RANGELINE PROPERTIES SUBDIVISION

APPLICATION NUMBER 32 DATE January 8, 2004
APPLICANT Rangeline Properties Subdivision
REQUEST Subdivision

RANGELINE PROPERTIES SUBDIVISION

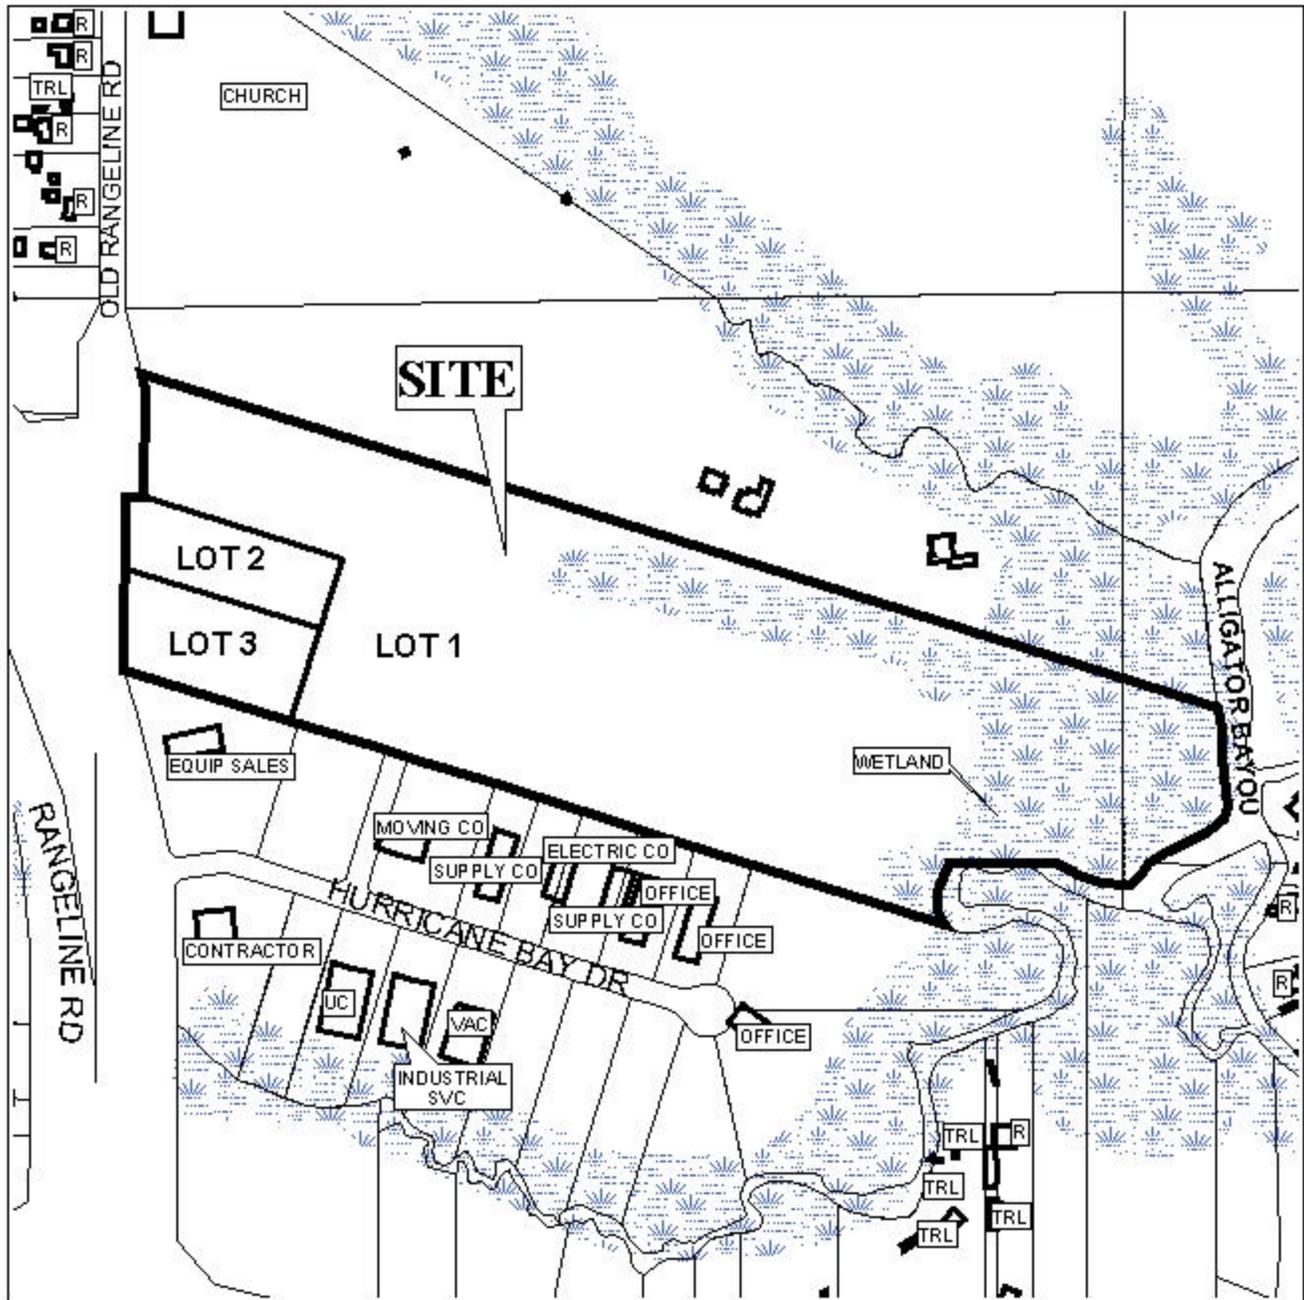
The site is located at the intersection of Old Rangeline and Rangeline Roads and access management is a concern. Therefore, the placement of a note on the final plat stating that Lots 1, 2 and 3 are limited to one curb cut each to Old Rangeline Road, with the size, location and design to be approved by County Engineering, should be required.

As proposed, Lot 1 would exceed the width to depth ratio, therefore a waiver of Section V.D.3. would be required.

The 25-foot minimum building setback lines are not shown but would be required on the final plat.

With a waiver of Section V.D.3., the proposed plat meets the minimum requirements of the Subdivision Regulations and is recommended for Tentative Approval subject to the following conditions: 1) the placement of a note on the final plat stating that Lots 1, 2 and 3 are limited to one curb cut each, with the size, location and design to be approved by County Engineering; 2) the developer to obtain the necessary approvals from federal, state and local agencies prior to the issuance of any permits; 3) the placement of a note on the final plat stating that any lots which are developed commercially and adjoin residentially developed property must provide a buffer, in compliance with Section V.A.7. of the Subdivision Regulations; and 4) the placement of the 25-foot minimum setback lines on the final plat.
